SAFETY EVALUATION BY THE OFFICE OF NUCLEAR REACTOR REGULATION
SUPPORTING AMENDMENT NO. 22 TO FACILITY OPERATING LICENSE NO. DPR-18

R. E. GINNA NUCLEAR POWER PLANT

DOCKET NO. 50-244

FIGURE 1

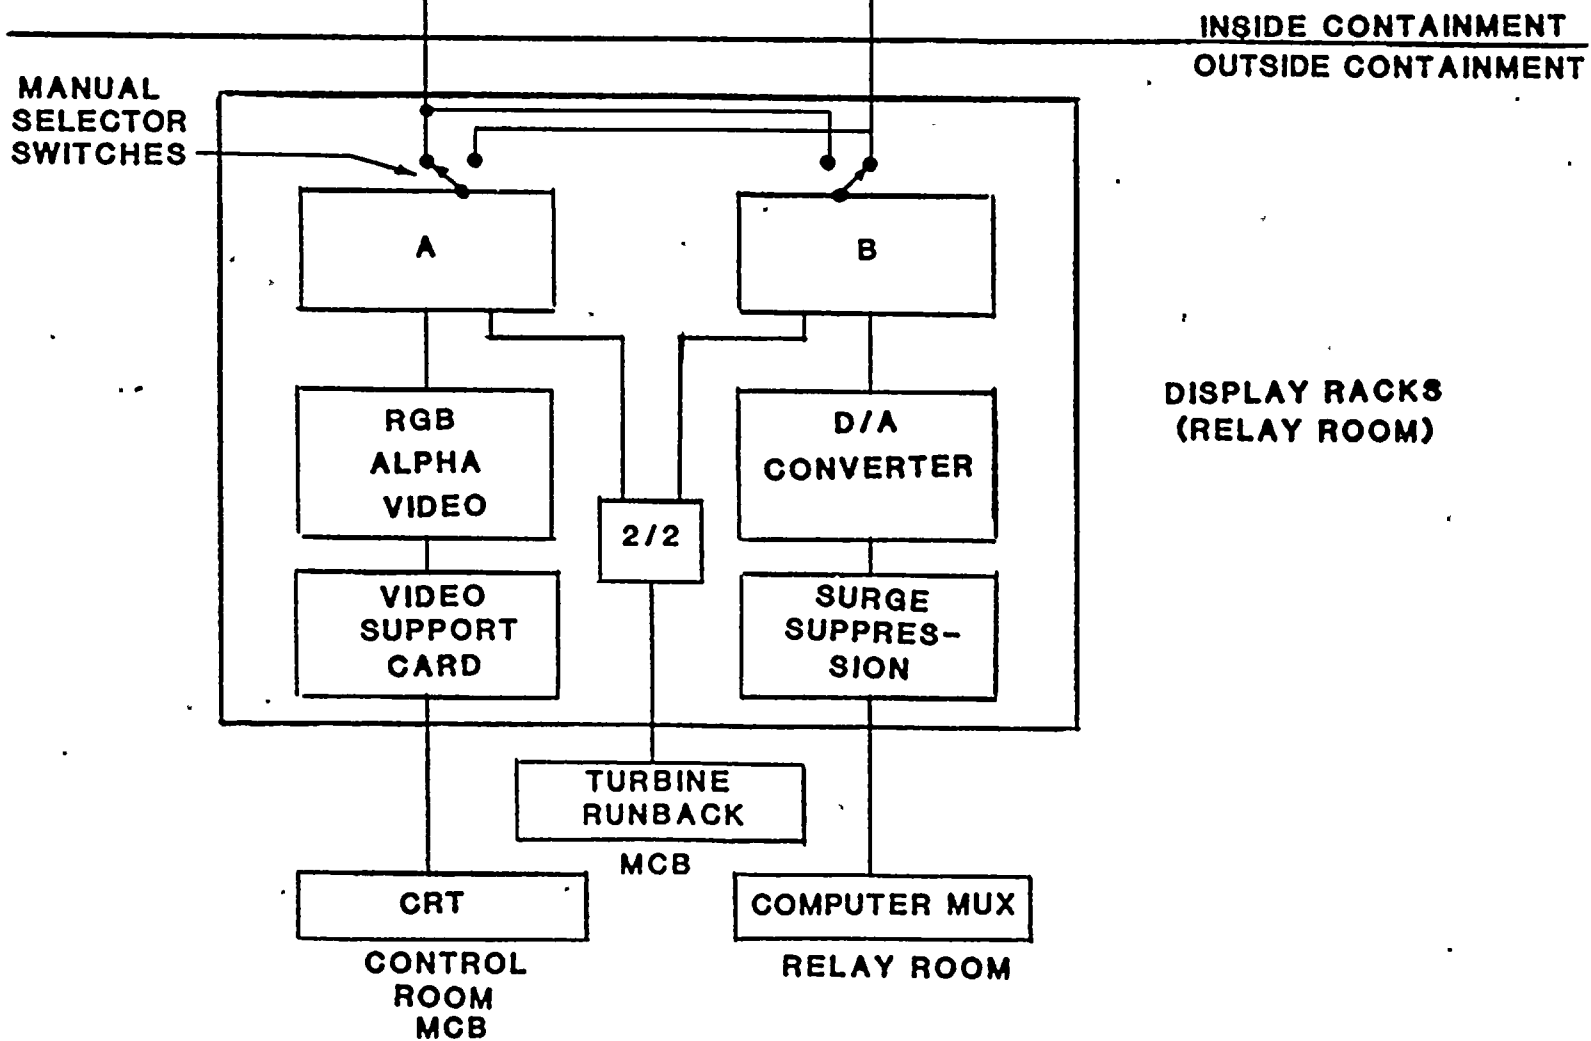
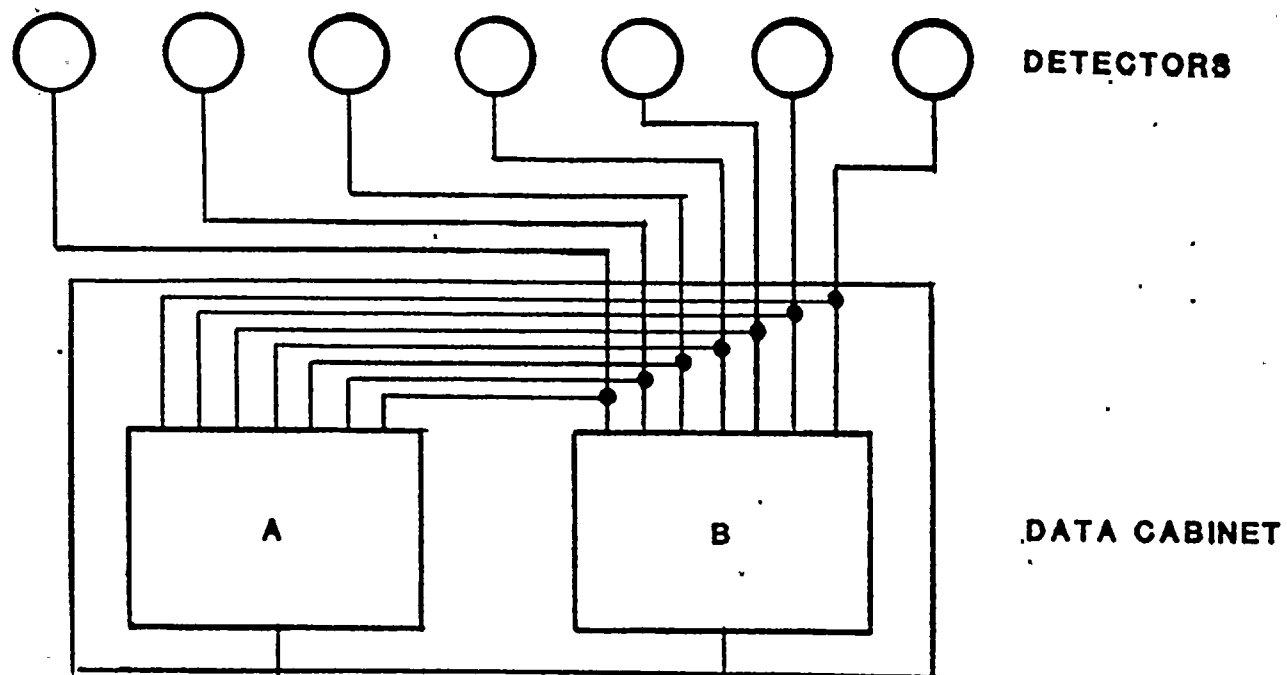
A block diagram of the MRPI system is illustrated in attached Figure 1. The system consists of a digital detector assembly for each rod, a data cabinet located inside containment, and display racks located in the relay room. Rod position data is displayed on a color cathode ray tube (CRT) in the control room and transmitted to the plant process computer system (PPCS). The data cabinet inside containment contains two multiplexers which take rod position information from each of the rods and transmit it to the processors which are in the display racks located in the relay room. One processor supplies information to the CRT located on the control board, the other processor supplies information to the PPCS. Both processors produce a turbine runback and block rod withdrawal signal.
